Auxiliary Battery Charging, Improvement

V-321-001

(December 2024)

Volvo truck models with USA21 emissions level, Aux. Power/Climate Systems and a Delco alternator.

Variable-Geometry Turbo	Turbocompound
-------------------------	---------------

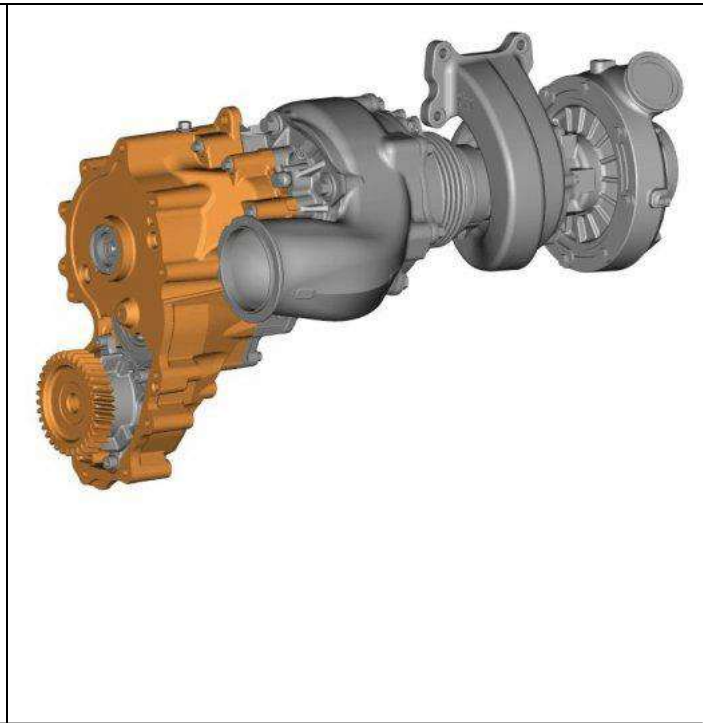
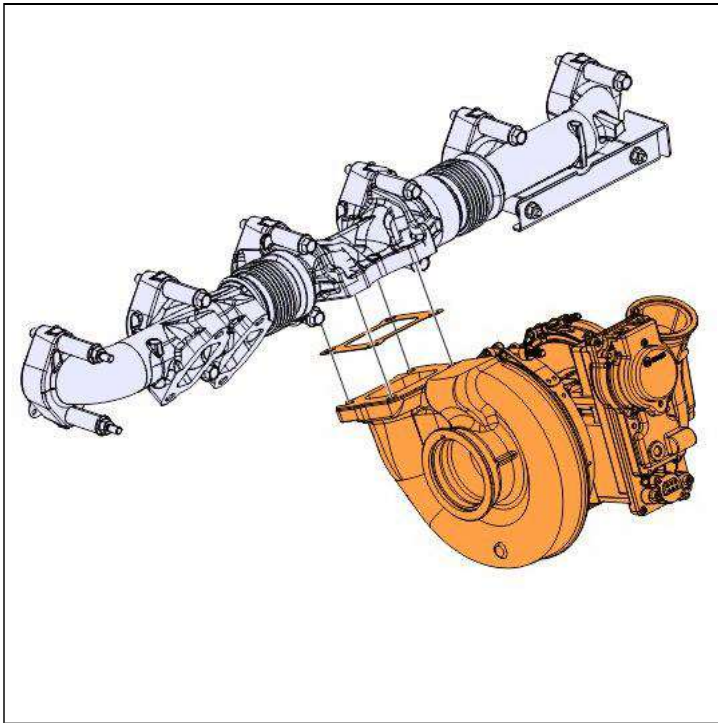
5. Determine which turbo configuration the truck has.

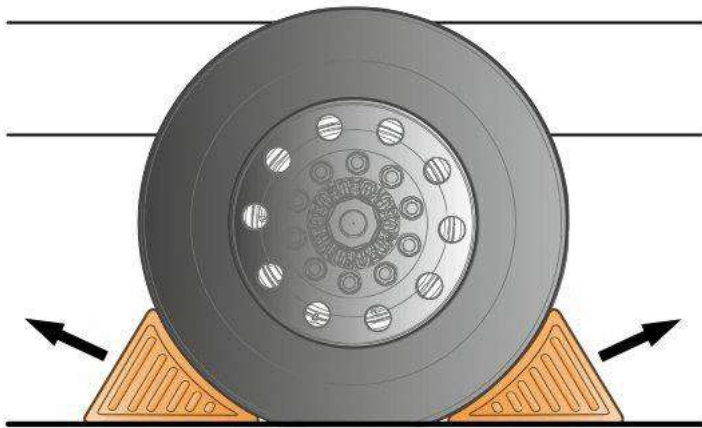
6. Replace parts according to turbo identification.

Variable-Geometry Turbo	Turbocompound
Replace Alternator Pulley with part number 23963356 and Alternator Belt with part number 24428844.	Replace Alternator Pulley with part number 23963356.
